WRITTEN STATEMENT OF CONDITIONS

The City of North Richland Hills received this plat on July 19, 2023. The Development Review Committee reviewed this plat on August 1, 2023. The following represents the written statement of the conditions for conditional approval of the plat.

**FINAL PLAT OF
LOT 12, BLOCK 10
HILVIEW ADDITION**

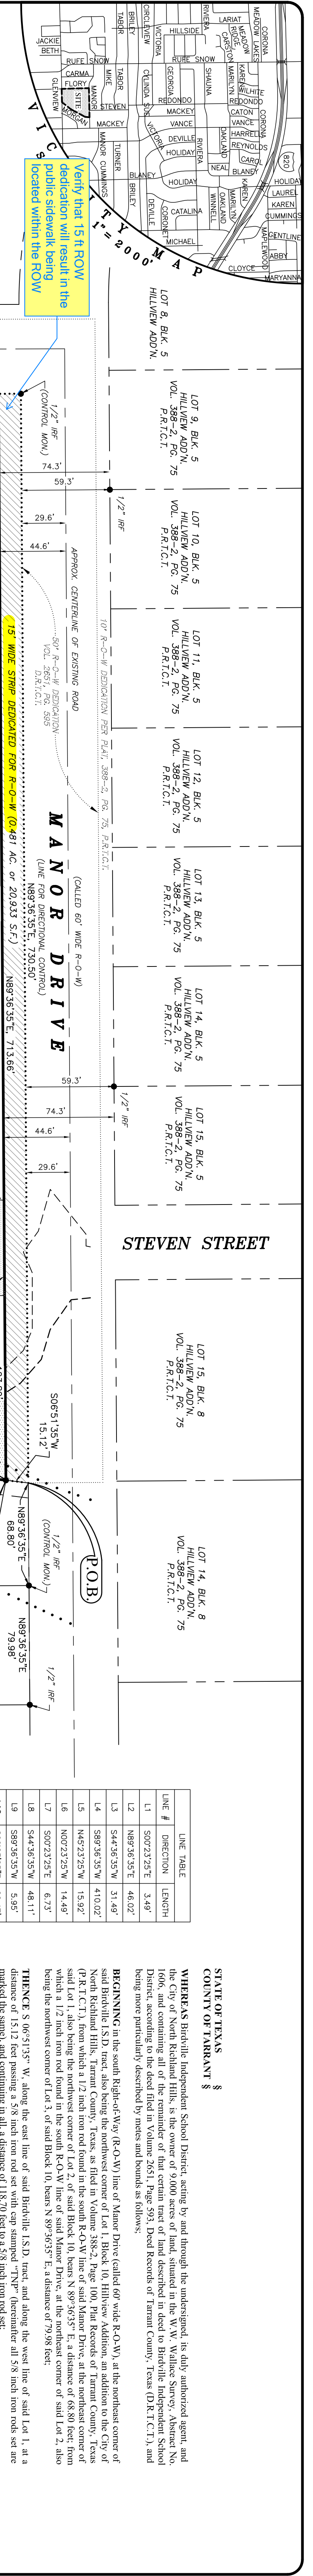
1. Add the following note to the plat: The easements indicated on this plat are for the purpose of constructing, using, and maintaining public utilities including underground conduits, manholes, pipes, valves, posts, above ground cables, wires, or combinations thereof, together with the right of ingress and egress to operate and maintain the public utilities. *NRH Subdivision Regulations §110-331 (Requirements for all plat drawings – plat notes and conditions)*

2. Add a 20-foot front building line adjacent to Flory Street and Manor Drive. This will correspond with the zoning of the property. *NRH Subdivision Regulations §110-331 (Requirements for all plat drawings – building setback lines)*

3. Verify that the 15-foot right-of-way dedication for Manor Drive and Flory Street is sufficient to include the new public sidewalk within the right-of-way. *NRH Subdivision Regulations §110-368 (Street right-of-way dedication) and §110-412 (Generally – rights-of-way)*

4. Add a drainage easement that encompasses the full AE zone plus one foot of freeboard. *NRH Subdivision Regulations §110-333 (Requirements for all plat drawings – drainage easements) and NRH Flood Damage Prevention Ordinance §102-83 (Standards for new development or subdivision proposals)*

1. Add the City case number near the bottom right corner of the drawings (Case PLAT23-0047).
2. Informational comments. These comments are informational only and do not need to be added to the drawing.
 - a. The property will retain its current address of 4100 Flory Street.

Verify that 15 ft ROW
dedication will result in the
public sidewalk being
located within the ROW

Does Kay Granger Park
need to be
separated out or
dedicated within
Plat? Parks
thoughts?

Drainage
Easement
needed for
100-year
floodplain plus
1-foot of
freeboard

NEEDS TO BE SEPARATED OUT OR DEDICATED WITHIN PLAT? PARKS THOUGHTS?

DRAINAGE EASEMENT NEEDED FOR 100-YEAR FLOODPLAIN PLUS 1-FOOT OF FREEBOARD
